**CONCORD HIGH SCHOOL
New High School Building**

BUILDING CODE OF AUSTRALIA 2022 & BCA ACCESS

100% SCHEMATIC DESIGN REVIEW

JUNE 2023

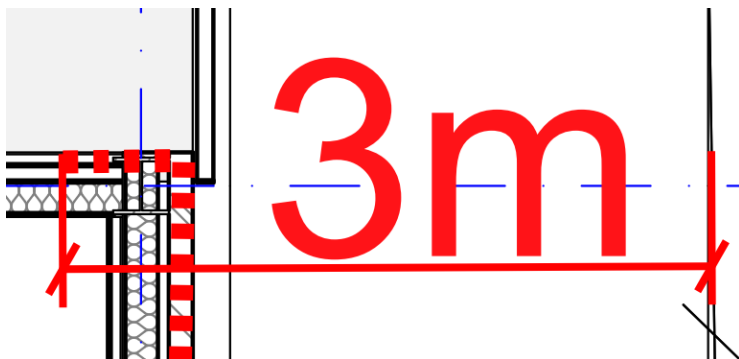
Please note that the 3m setback for the non loadbearing external walls extends along the face of the first aid room.

Please note that where the fire source feature changes from the side boundary to the far boundary of the road (Stanley Street) has to be confirmed. Refer to the BCA definition below.

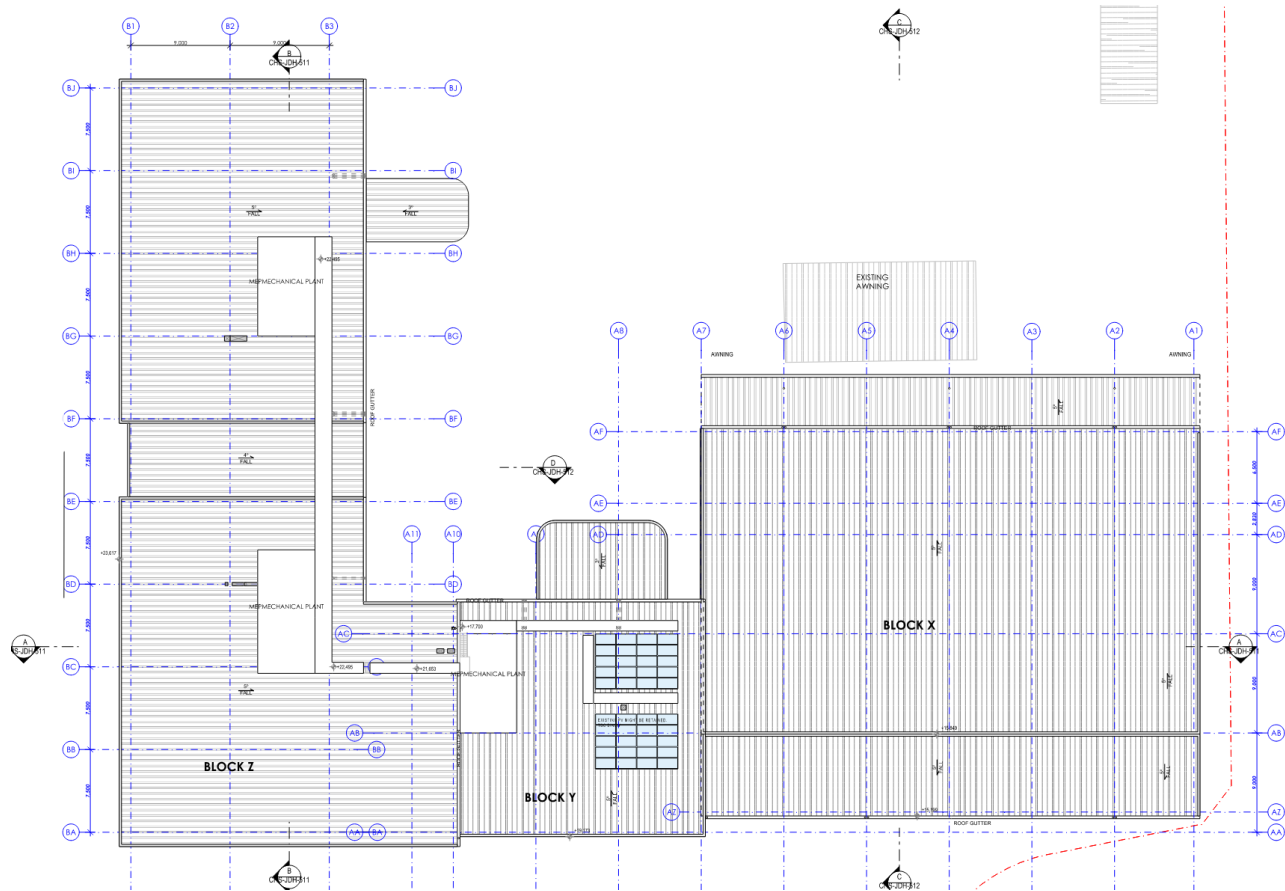
This applies to the proposed fire-isolated stair shaft at grid A11/BA, the lift shaft and any services shafts.

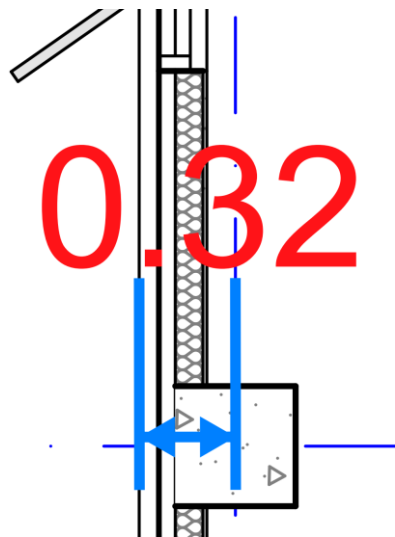
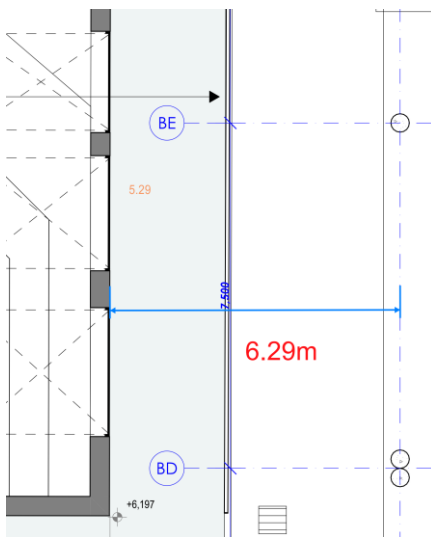
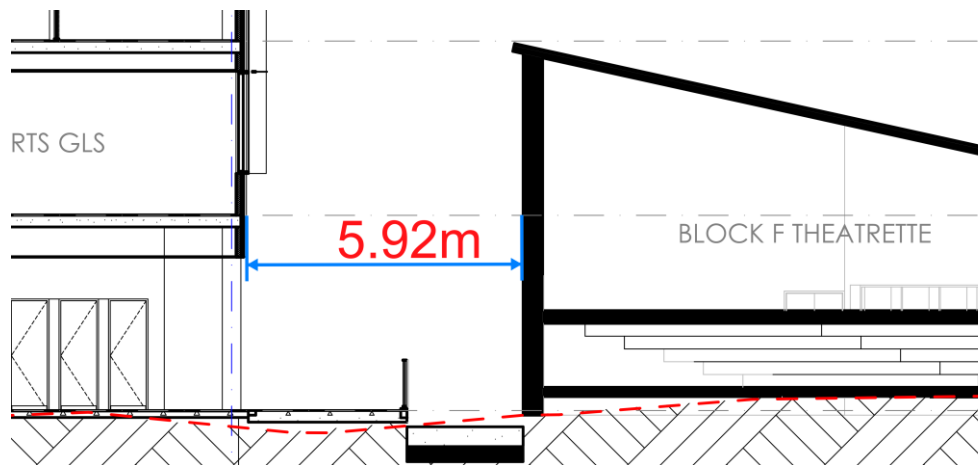
See below a markup showing the setback of the Building F external walls from Grid line B1 and the location of the external wall in relation to grid line B1. The setback of the Building F external wall from the proposed level 1 external wall is approximately 5.97m. The exact setback is required to be confirmed as the 1:200 sections show the distance to be 5.92m.

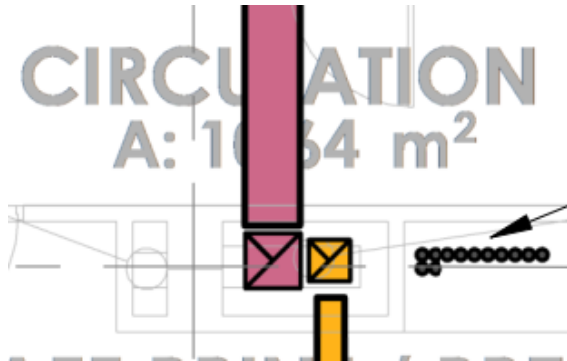
The developed design drawings are required to show the fire dampers in the fire rated shafts eg see the mechanical services shaft at grid BD / B2 below.

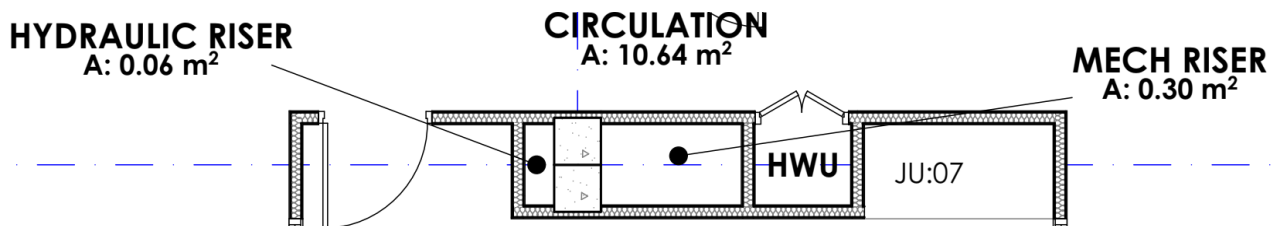
The developed architectural drawings are required to clarify if the services reticulate through the building in shafts or risers so that the appropriate protection can be specified to the service penetration of the fire rated building element. Note that the walls of non loadbearing shafts are required to have an FRL of -/90/90 and the service penetration through the walls of the shaft (ie not the floor slab) are required to be protected eg fire dampers to mechanical services shafts. Note that walls of risers are not required to have an FRL as the floor slab continues and the service penetration of the floor slab is required to be protected eg fire pillows to electrical services risers.

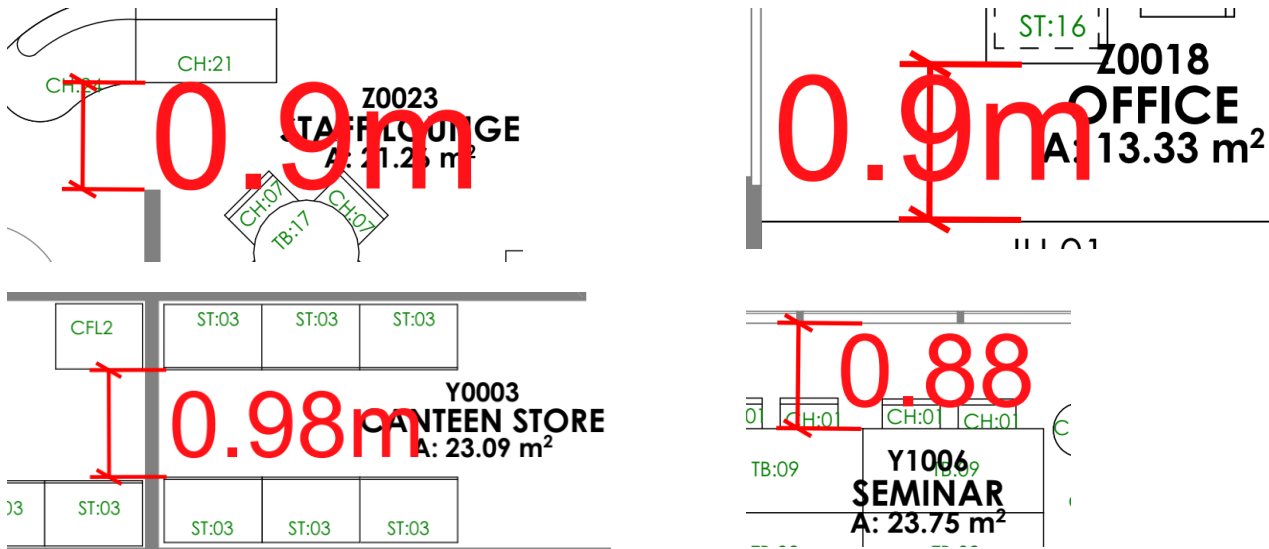
The internal connection between each room (General Learning Space rooms, Workshop rooms etc) with sliding doors shall be freely openable for an alternative egress route during a fire emergency. [MCD Fire: We will require a fire trip to allow free passage from common learning to GLS. It is not only to do with the travel distance but also vital for the performance solution for external stairs.

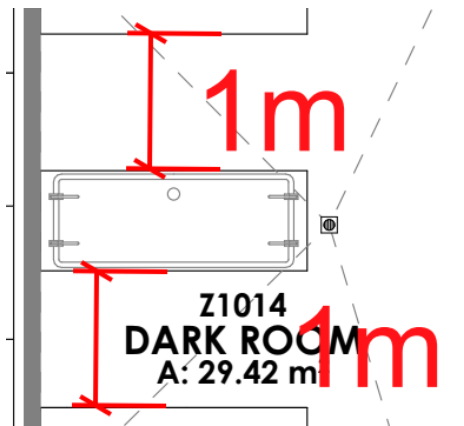
The clear width of the path of travel in the following locations is required to be modified to achieve a minimum dimension of 1m and a construction tolerance is recommended eg 1050mm.

Where possible provide a construction tolerance to the 1m min clear paths of travel eg 1050mm.

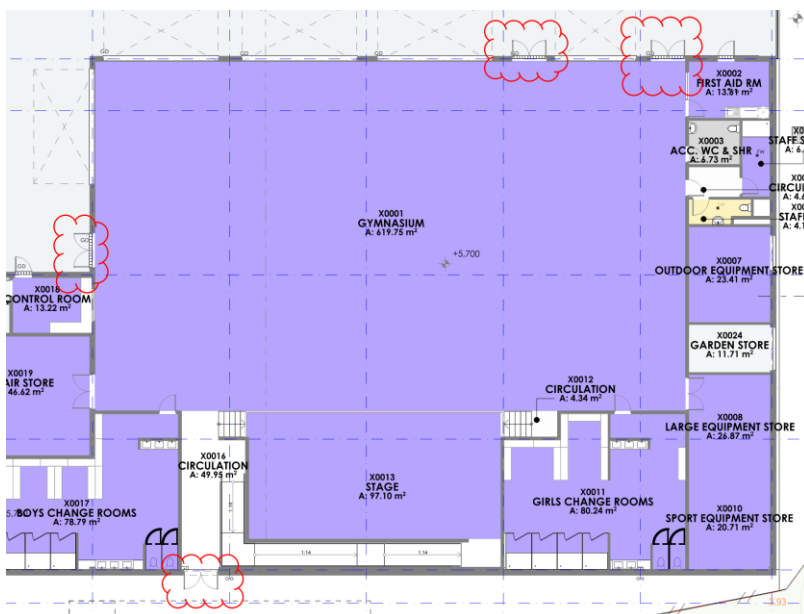
The double doors exits provided in the ground floor gymnasium will serve a maximum population of 950 people based on an aggregate egress width of 7.2m. These widths are to be reassessed after the issue of the door schedule.

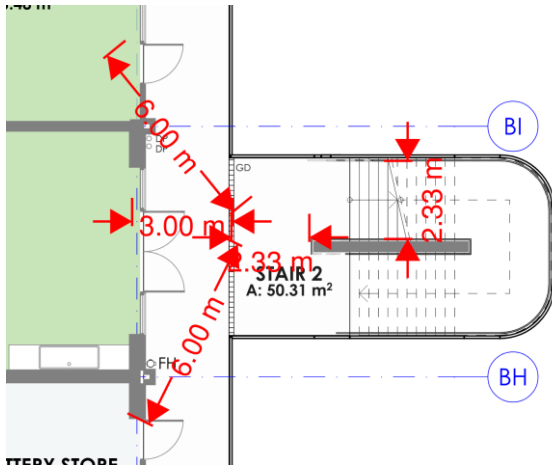
Stair 2 connects 4 storeys and is proposed to be an external stairways in lieu of fire isolated stairs and is required to comply with the following requirements. (Stair 3 only connects 3 storeys in a sprinkler protected building and is not required to comply with these requirements.)

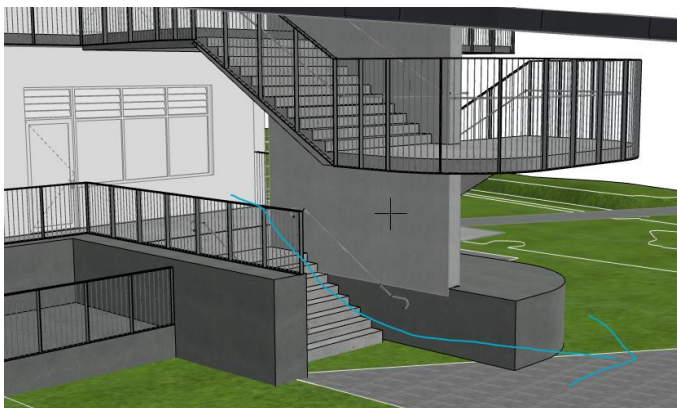
The discharge path from the base of Stair 2 is directly to the open space as shown in the figure below.

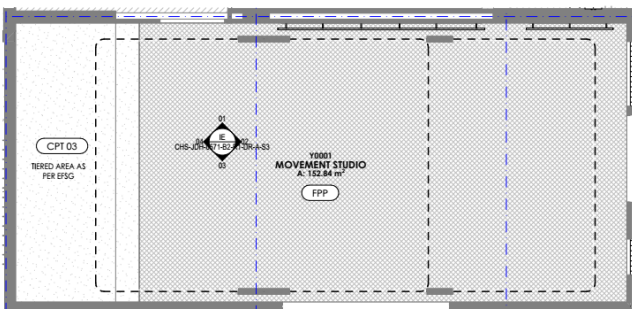
Please confirm if the sliding doors from the learning common to the GLs will be free passage from the learning common side. If they are not then note that the fire engineer will require a fire trip to be provided.

MOVEMENT STUDIO PLAN
SCALE 1:100

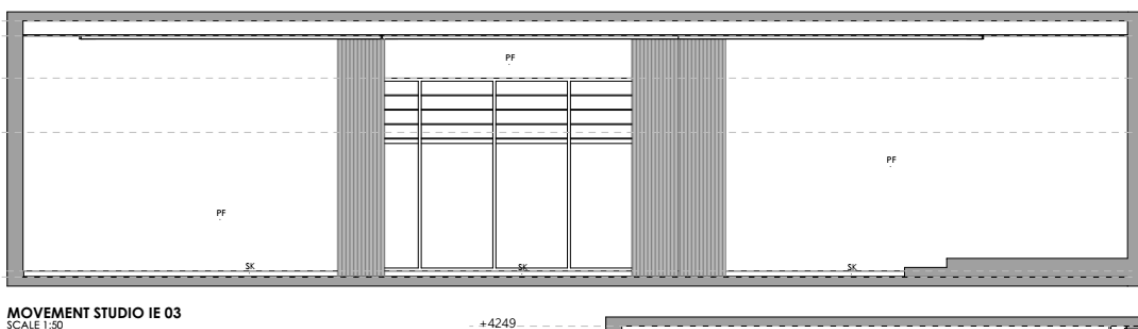
The BCA states that disabled access is required to be provided to and within all areas in the proposed building that are normally used by the occupants. The lower level of the covered outdoor space at the northern end of the building does not comply with this requirement and access is required to be provided to the space.

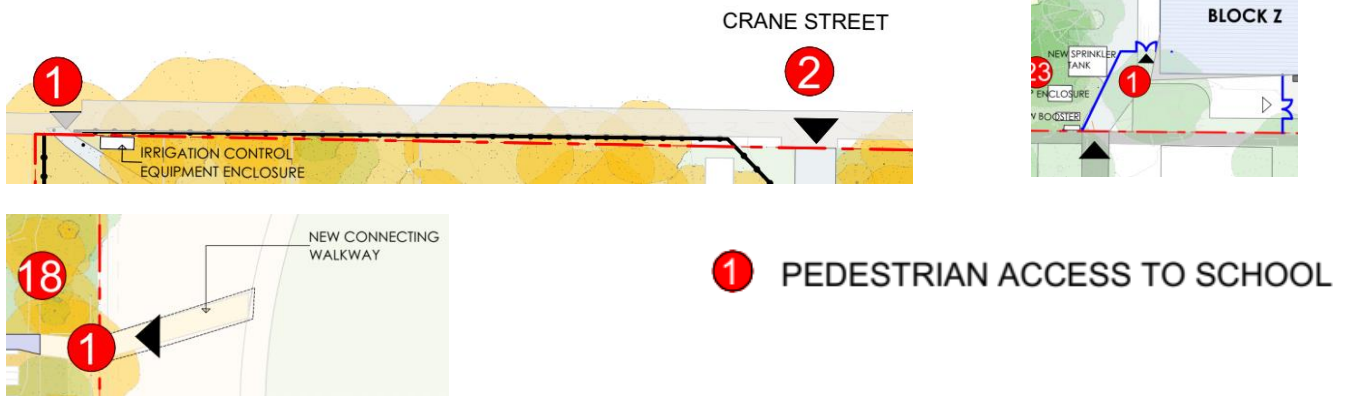
The developed design drawings are required to clarify which of the pedestrian access points at the boundary are the main point / points of pedestrian entry and these are required to provide an accessible path of travel to the proposed building.

After the main points of pedestrian entry at the allotment boundary are confirmed the extent of upgrade of any existing paths that connects the entry to the proposed building can be identified.

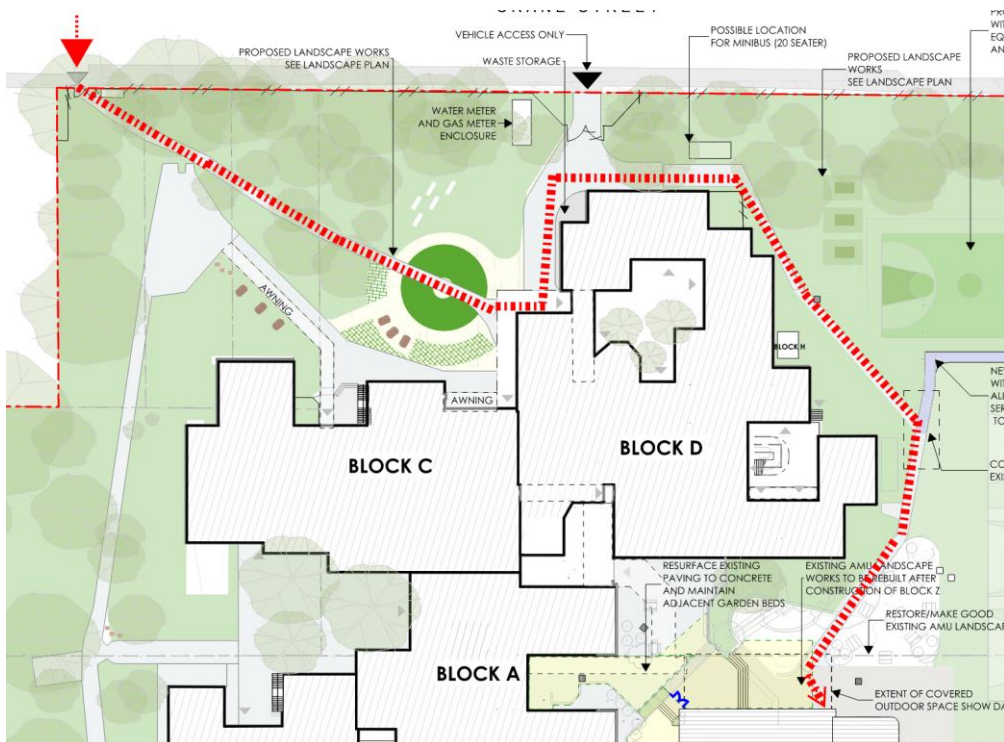
If the gate at Crane Street is a main point of pedestrian entry at the allotment boundary the path to the proposed building is required to be upgraded so that it complies with the requirements of AS1428.1 2009. Refer to comments in the BCA audit of existing conditions report on the compliance of the existing paths.

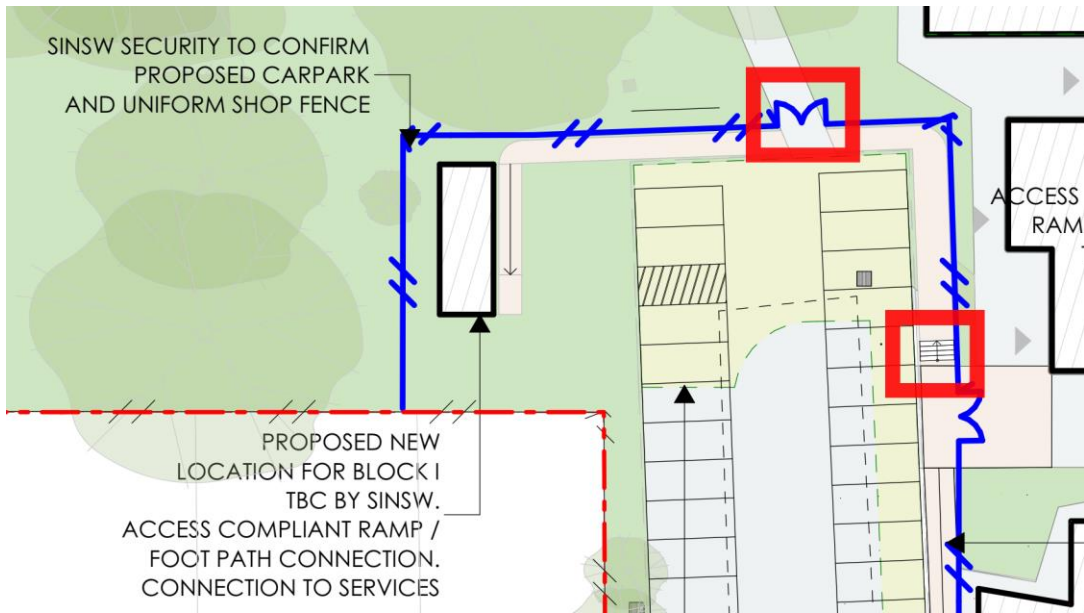
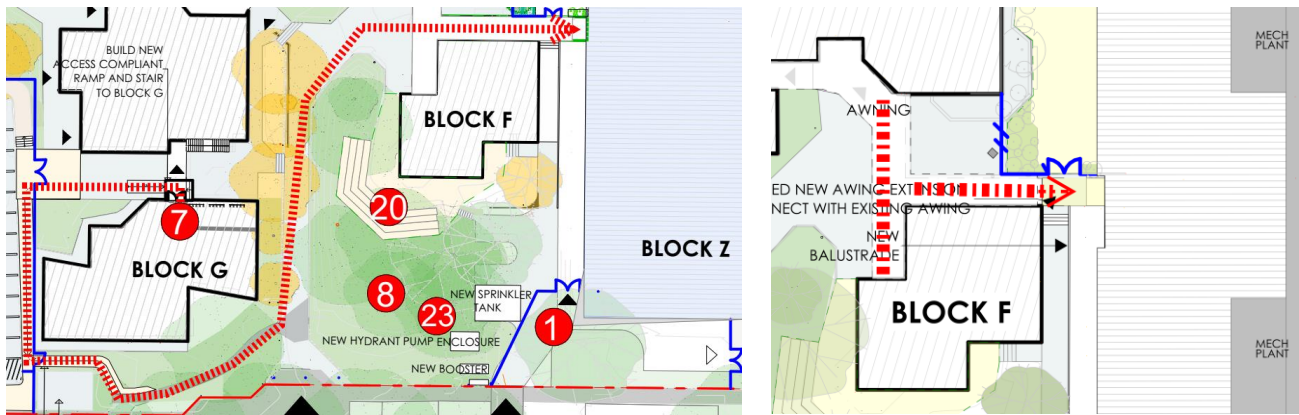
Further details are required to be provided that show how access between the new building, relocated uniform store and surrounding buildings is achieved. Note that existing pathways connecting the existing buildings may need to be upgraded.

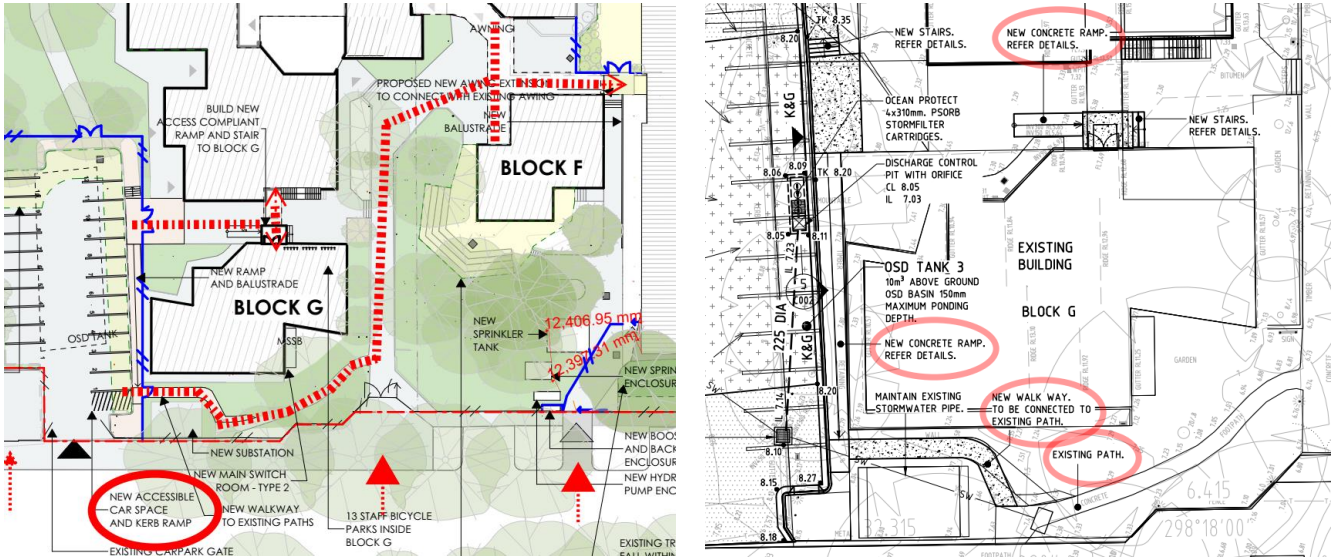
Please note that the existing pathways connecting the proposed accessible carspace to the accessible building may need to be upgraded to achieve compliance to the requirement of AS1428.1 2009 and details are required to be provided within the developed design drawings.

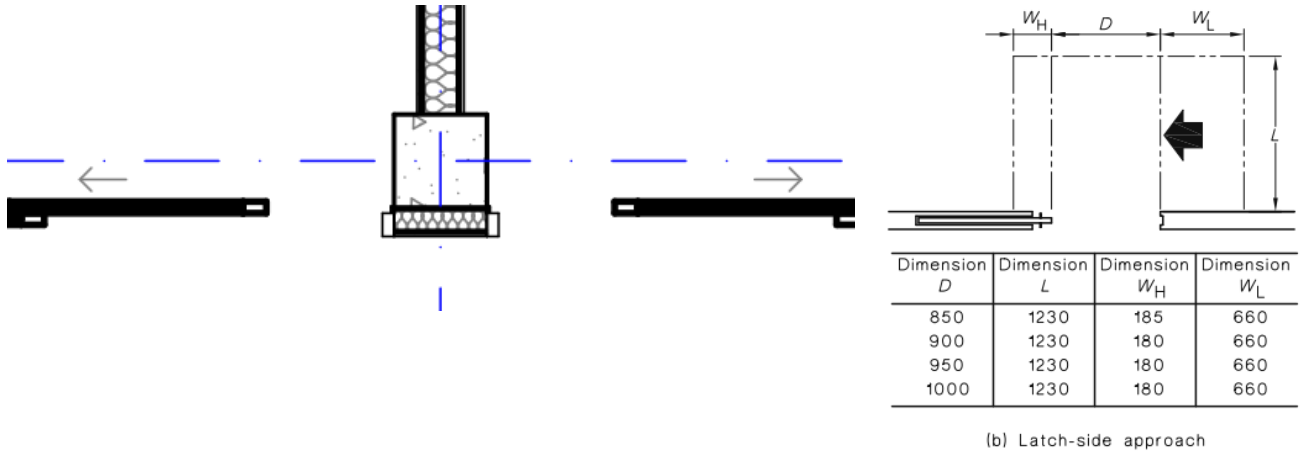
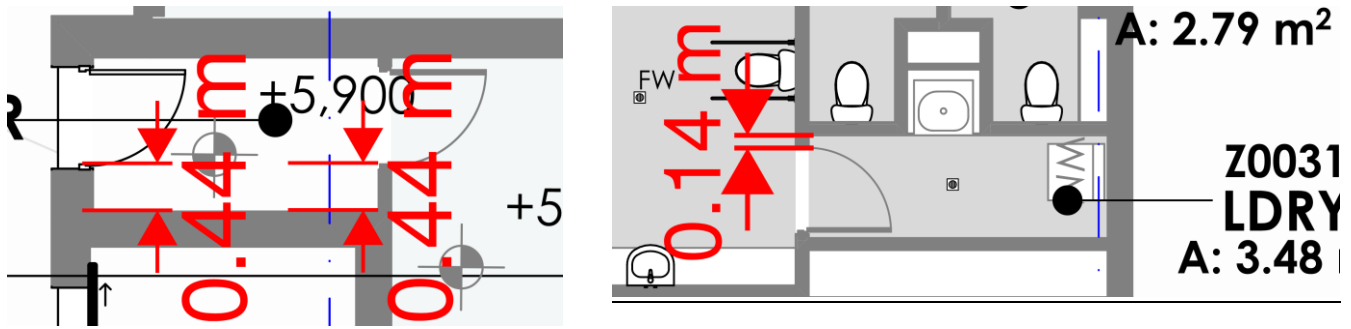
The circulation spaces of the following doorways is required to be modified to meet the minimum requirements of AS 1428.1 2009.

All sliding doors are required to be provided with a minimum internal latch side circulation space of 395mm and a tolerance is recommended. See examples below.
